**Subject:** Riverkeeper, Inc.'s Comments on the Indian Point License Renewal DSEIS,  
Docket Nos. 50-247 and 50-286  
**Sent Date:** 3/18/2009 8:50:31 PM  
**Received Date:** 3/18/2009 8:51:14 PM  
**From:** Deborah Brancato

Re: Riverkeeper, Inc.'s Comments on the U.S. Nuclear Regulatory Commission's Generic Environmental Impact Statement for License Renewal of Nuclear Plants, Supplement 38, Regarding Indian Point Nuclear Generating Unit Nos. 2 and 3, Draft Report for Comment, Docket Nos. 50-247 and 50-286

**Figure 2: The standardised juvenile index for white catfish in the Hudson, showing a decreasing trend though time. The trend is significant (a = -0.0136, b = 27.216, F = 14.0414, p = 0.0008) (Seaby and Henderson, 2007)**

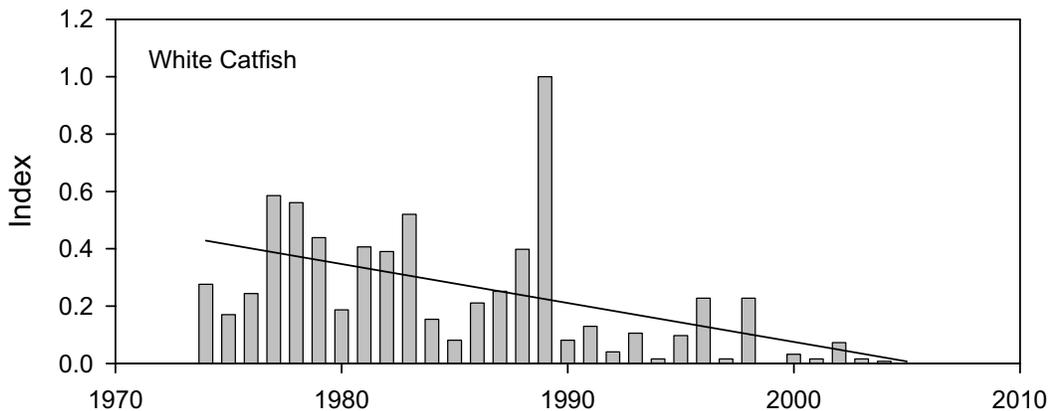
The Year Class Reports for the Hudson River Estuary Monitoring Program shows that, river-wide, juvenile white catfish have been in a steep decline in abundance since 1990 (Figure 2).

It is therefore unsurprising that in Table 4-4 (see Figure 1) the population line of evidence is for a ‘Large’ potential adverse impact. The trend shown in Figure 2, which is statistically significant, certainly seems to correspond with the definition of Large given on page H-33, NUREG-1437, Vol 2:

**Figure 3: The standardised juvenile index for weakfish in the Hudson showing a decreasing trend though time. The trend is significant (a = -0.0155, b = 31.0218, F = 7.0811, p = 0.0134) (Seaby and Henderson, 2007)**

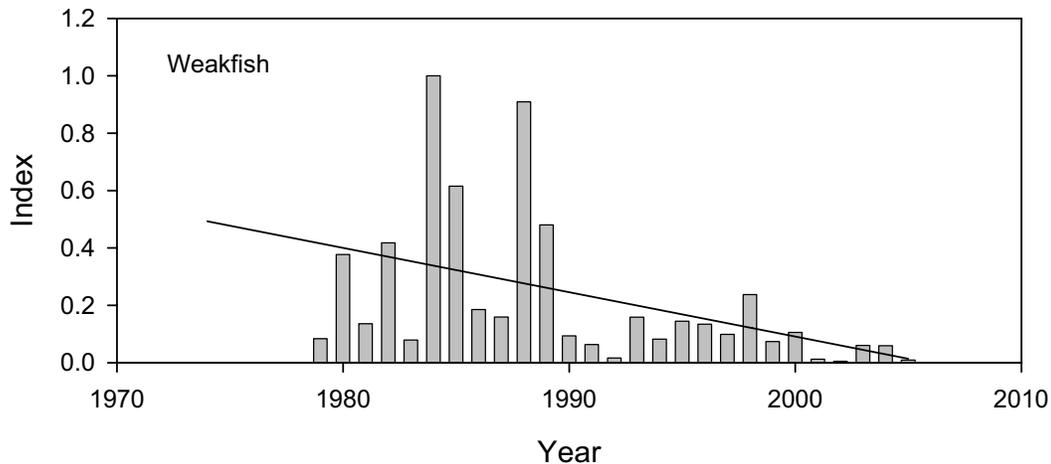
Like white catfish, weakfish have also shown river-wide a steep decline in abundance since 1990 (Figure 3). However, unlike white catfish, for this species Table 4-4 classifies the population line of evidence as ‘Small’.

A ‘Small’ potential for adverse impact is defined on page H-32 vol 2 as:

Figure 5: The standardized juvenile index for rainbow smelt in the Hudson.

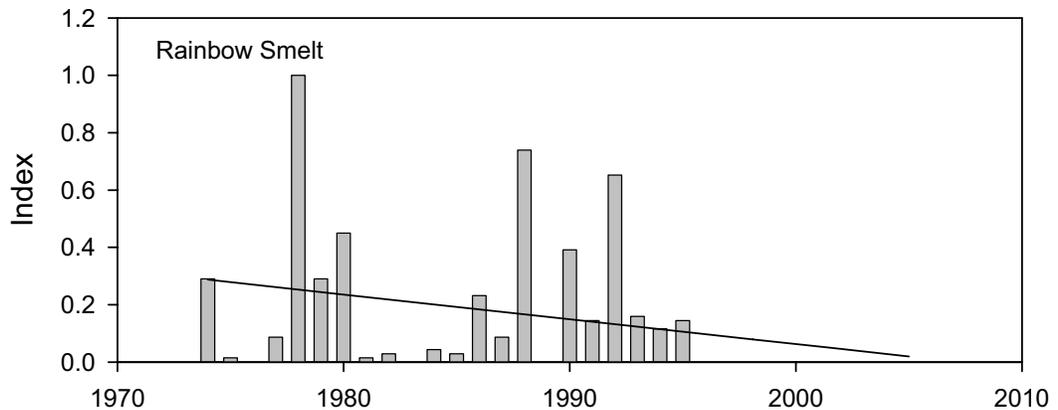
Juvenile rainbow smelt have disappeared from the survey since the mid 1990s (Figure 5), and it is therefore unsurprising that Table 4-4 assesses the population line of evidence as ‘Large’. However, the impact of Indian Point 2 and 3 is assessed as moderate because the strength of connection is assessed as ‘Medium’.

Examination of Table I-32 (Figure 4) shows why the overall impact is only 'Moderate'. This table shows that both the impingement and entrainment of rainbow smelt has been appreciable, and entrainment has been given the highest score possible of 4. However, the strength of connection is only medium because both the impingement and entrainment prey scores are 1. The reason for this is stated in NUREG-1437, Vol. 2 page I-41.

**Figure 6: The standardised juvenile index for tomcod in the Hudson showing a decreasing trend though time. (Seaby and Henderson, 2007)**

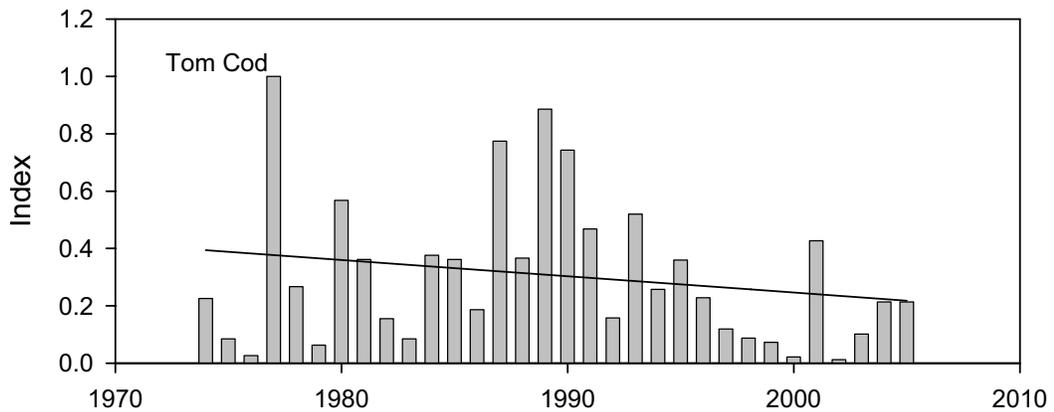
Examination of Table I-32 (Figure 4) shows that a number of the RIS species have a prey score for impingement and entrainment of 1, and thus are unlikely to score highly for the strength of connection. This feature of the scoring protocol is thus central to the final outcome. The Atlantic tomcod makes a telling further example. The tomcod population shows considerable year-to-year variation, but appears to be in long-term decline (Figure 6). The average standardised index from 1975 until 1995 is 0.158; in comparison the index for the last ten years of sampling (1996-2005) is only 0.0617. In the last 10 years, only 2001 produced a good recruitment, although there are signs of a recent slight improvement in tomcod numbers.

While the population line of evidence for a decline is large, the invertebrate prey of this species is primarily responsible for the low-to medium strength of connection and the final conclusion that the impact is small to moderate.
